ASSESSMENT REPORT

RASP ZINC-LEAD-SILVER MINE PROJECT Ventilation Shaft Modification (07_0018 MOD 1)

Figure 4: Proposed waste rock management

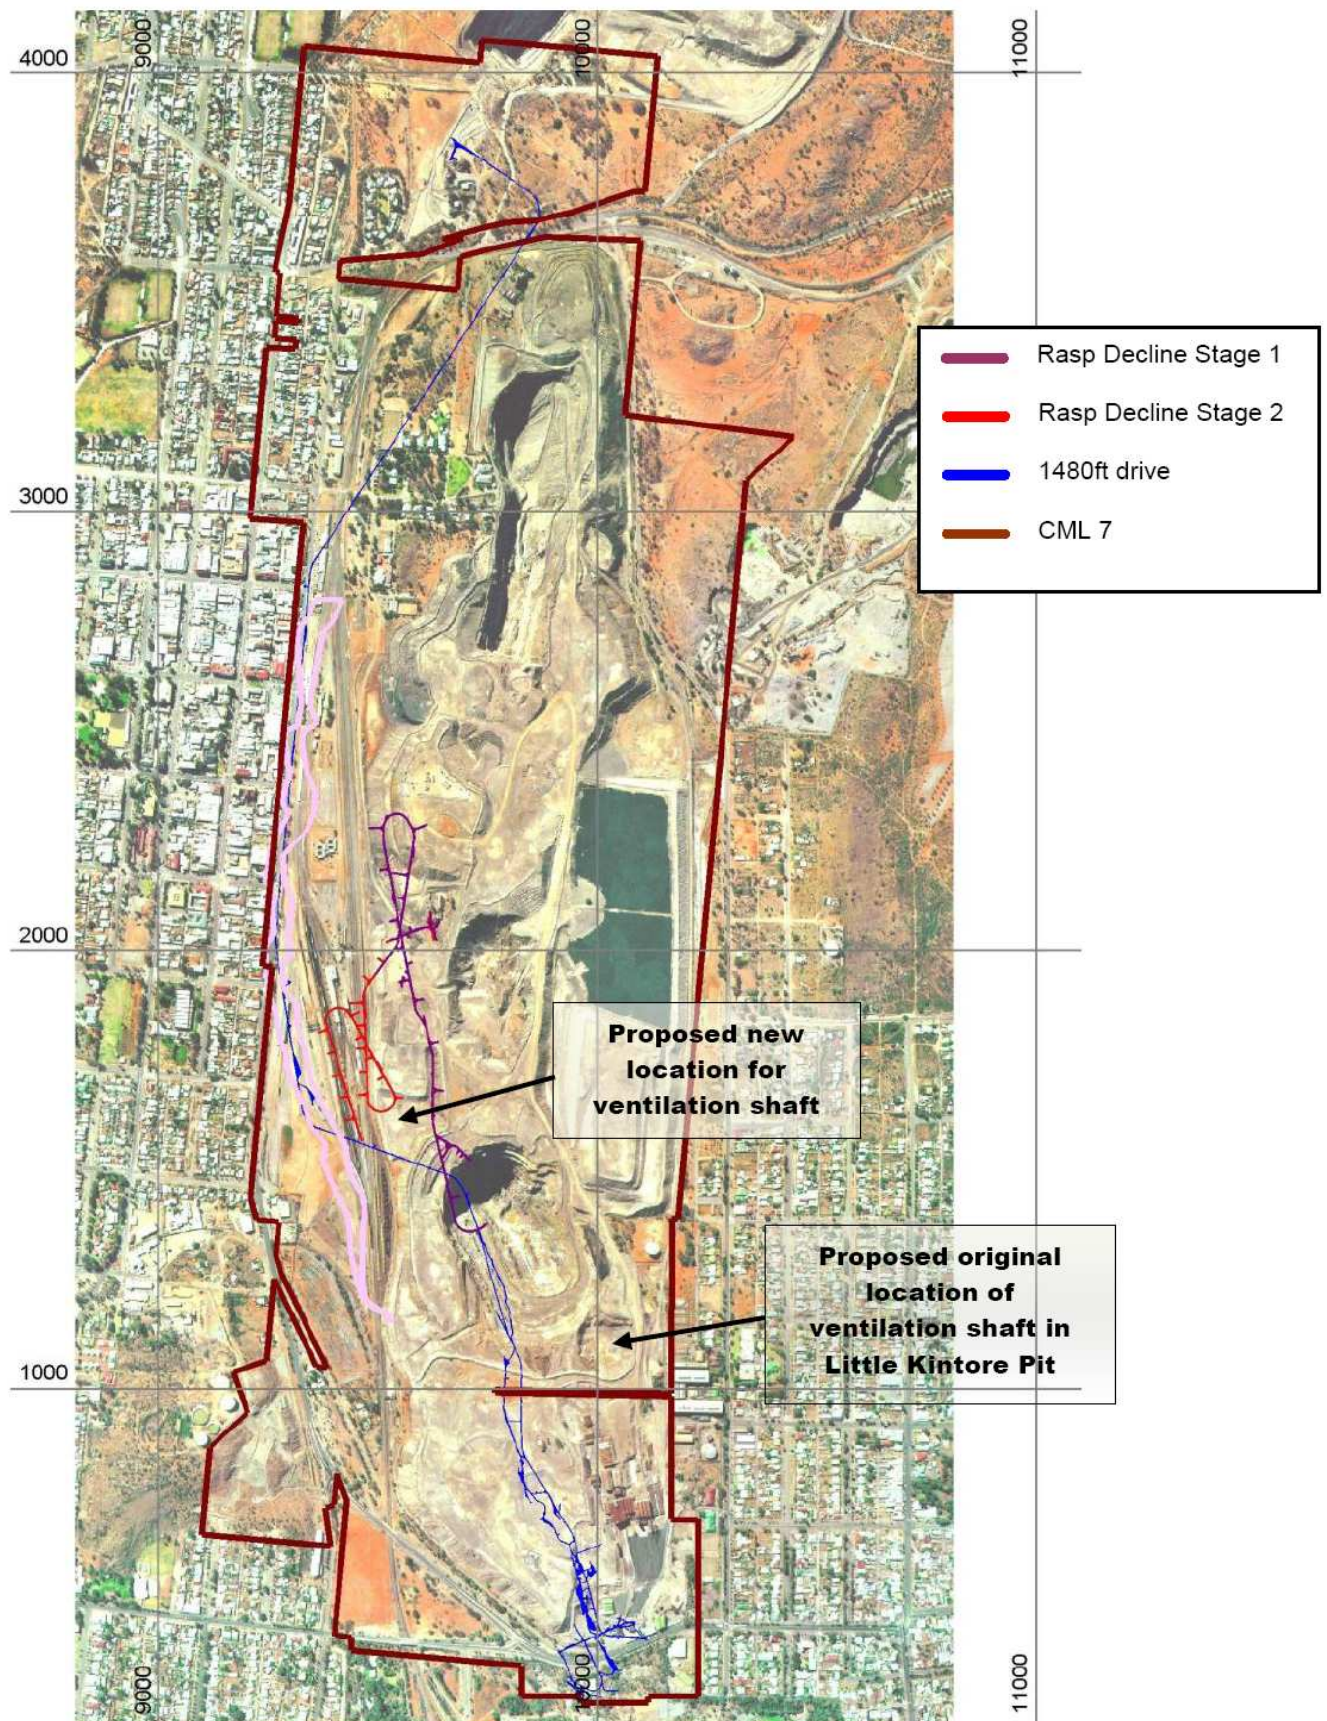
Waste	<p>Earthworks associated with the modification would result in the handling of an additional 46,500 tonnes of waste rock compared with the approved project.</p> <p>Approximately 30,000 tonnes of waste rock would be relocated by surface excavation works</p>

<p>around the duct/diffuser area, and would be reused to construct bunds around this area as shown in Figure 4. The remaining 16,500 tonnes of waste rock would be generated by the raise bore excavation of the shaft, and would be reused as road base within the underground mine.</p> <p>The Department notes that the handling and management of waste rock on the surface of the project site would be undertaken over a short time period and is a relocation of waste rock already on the project site. No additional waste rock would be delivered to the surface, nor would waste rock be transported off-site.</p> <p>The existing project approval requires the Proponent to review and revise its Waste Management Plan to incorporate the modification. With the implementation of a revised plan, the Department is satisfied that any waste impacts as a result of the proposed modification would be minimal and consistent with the approved project.</p>
